# 1966 - 1967 Corvette: Service Bulletin: Crankshaft to Water Pump Drive Belt Failure

**Model and Year:** 1966 - 1967 Corvettes with 427 CU. IN. Engine and Air Conditioning

**Bulletin No:** 67-T-26

**Date:** Sept. 26, 1967

FIG. 1

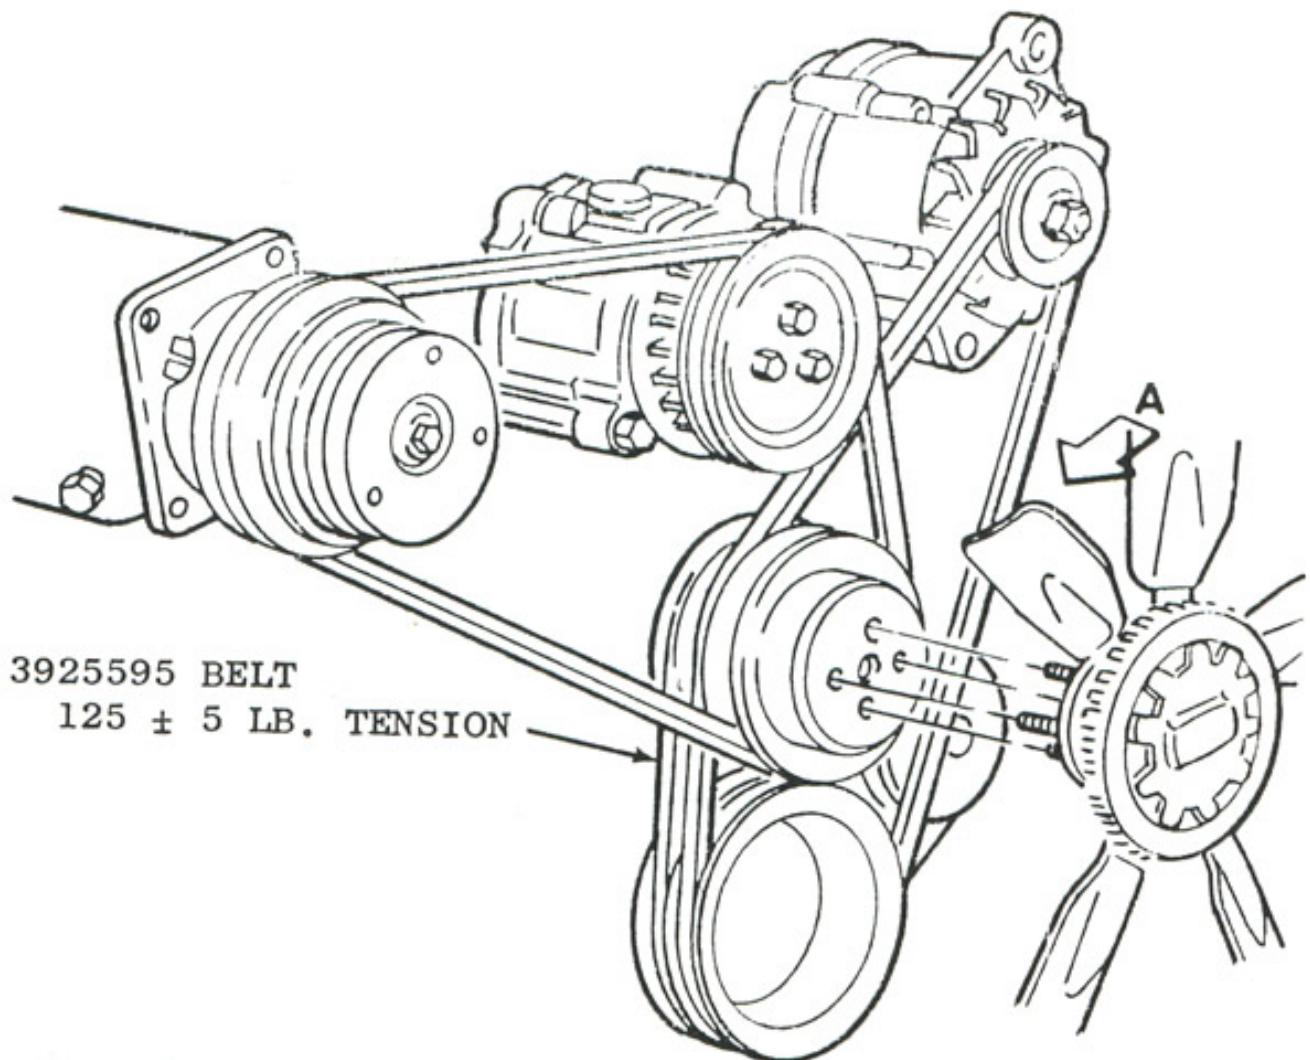
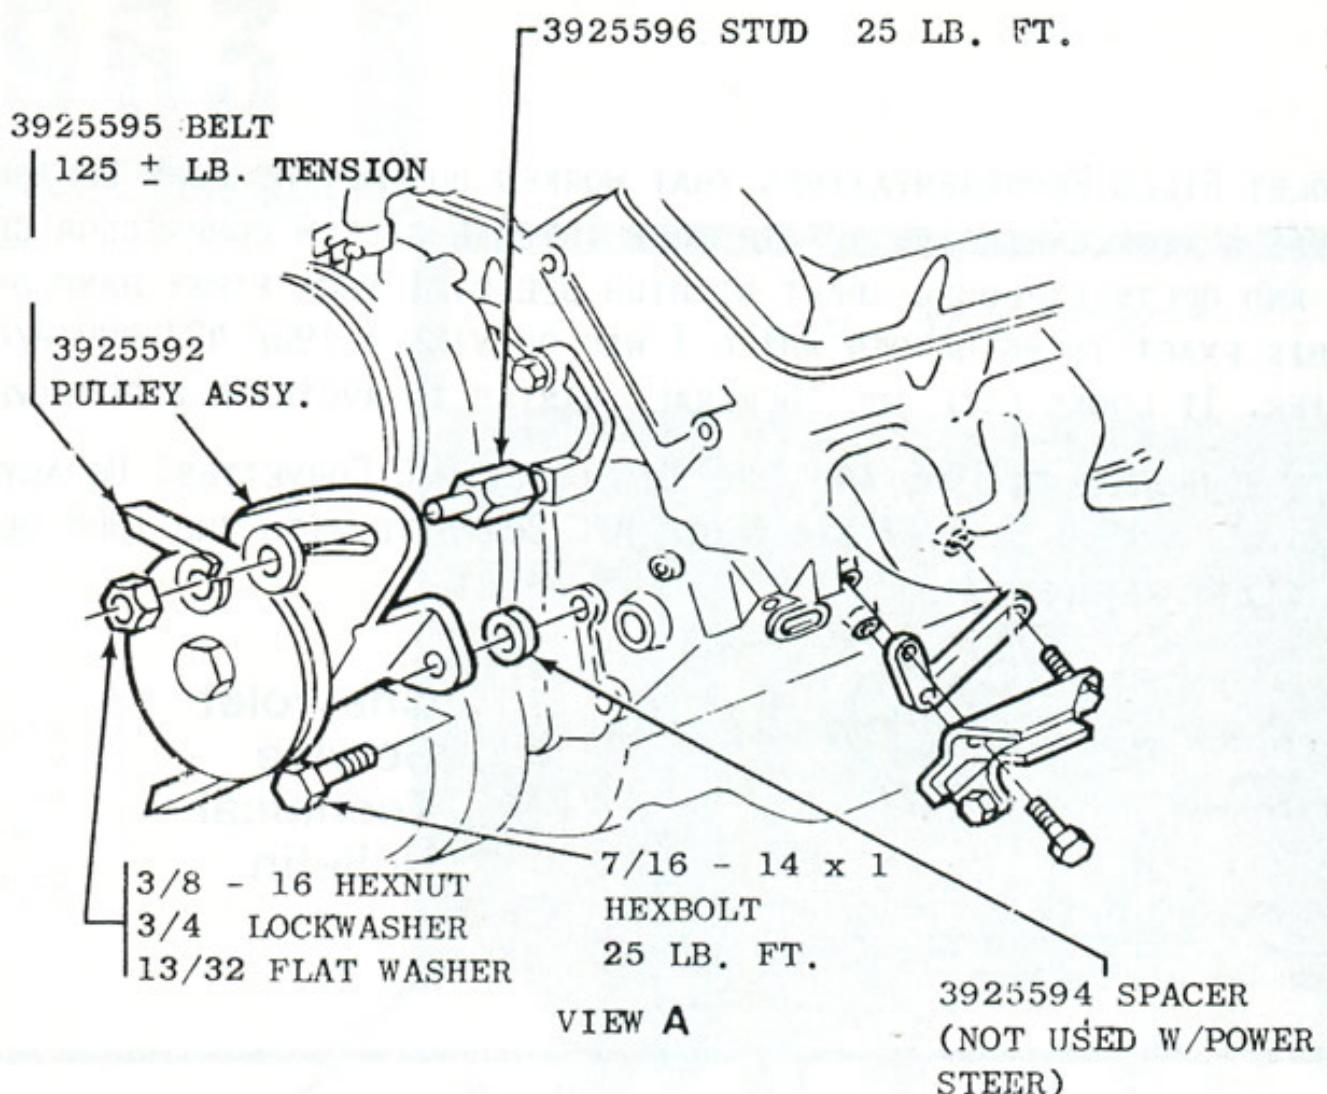
Reports have been received of crankshaft to water pump drive belt failures on 1966 and 1967 Corvettes equipped with 427 cubic inch engine and air conditioning. The belt failure occurs when the air conditioning compressor stalls under high head pressure after extreme hot soak conditions. With the compressor stalled, the water pump and the drive belt between the crankshaft and water pump also stall. As the crankshaft pulley continues to rotate, the crankshaft to water pump drive belt fails due to overheating and wear.

To permit belt tension adjustment between the crankshaft and water pump, 1968 Corvettes equipped with 427 cubic inch engine and air conditioning will incorporate an idler pulley shown in Figure 1.

In service, a similar idler pulley and longer drive belt can be installed to permit belt tension adjustment and correct the condition of belt slippage and wear. Parts information and installation instructions are illustrated in Figure 1
